WATTS BAR NUCLEAR PLANT (WBN) UNIT 1 - CHANGES MADE TO THE WBN TECHNICAL SPECIFICATION BASES AND TECHNICAL REQUIREMENTS MANUAL

WBN TECHNICAL SPECIFICATIONS BASES - CHANGED PAGES

WBN TECHNICAL REQUIREMENTS MANUAL - CHANGED PAGES

TECHNICAL REQUIREMENTS FIGURE 3.1.6
BORIC ACID TANK LIMITS
BASED ON RWST BORON CONCENTRATION
For 0 to 240 TPBARS

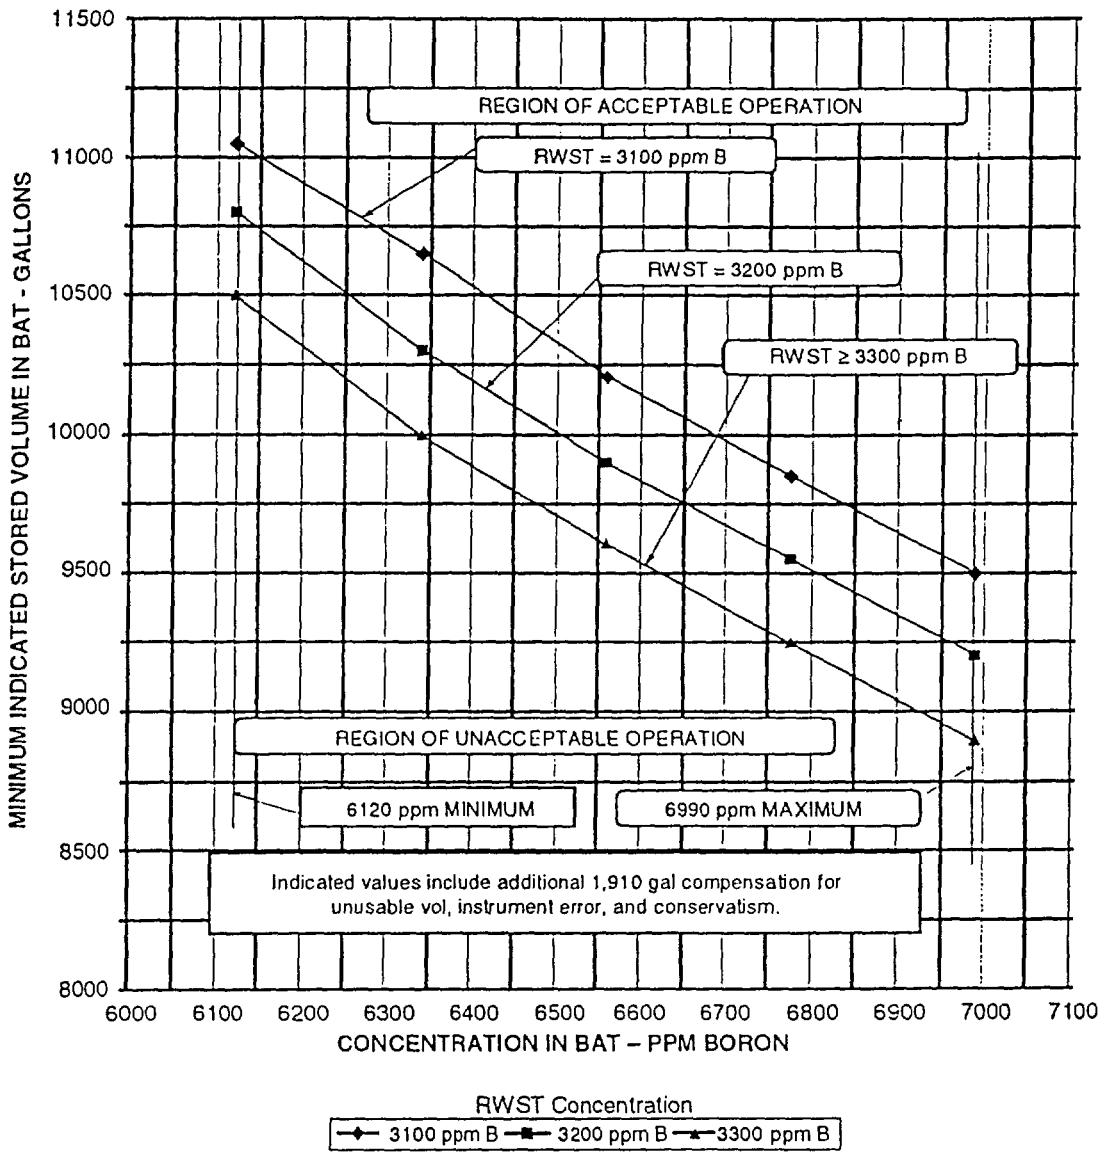
This surveillance requires verification every 7 days that the BAT borated water volume is in accordance with Figure 3.1.6 (the values listed on the figure do not account for instrument error). This borated water volume at the boron concentration specified in TSR 3.1.6.5 is sufficient to provide an adequate SDM. Since the BAT volume is normally stable, a 7-day Frequency to verify borated water volume is appropriate and has been shown to be acceptable through operating experience.

The maximum expected boration capability requirement occurs near EOL from full power peak xenon conditions and requires borated water from a boric acid tank in accordance with Figure 3.1.6, and additional makeup from either (1) the common boric acid tank and/or batching tank, or (2) a maximum of 22,000 gallons of 3,100 ppm borated water from the refueling water storage tank. With the refueling water storage tank as the only borated water source, a maximum of 61,000 gallons of 3,100 ppm borated water is required.
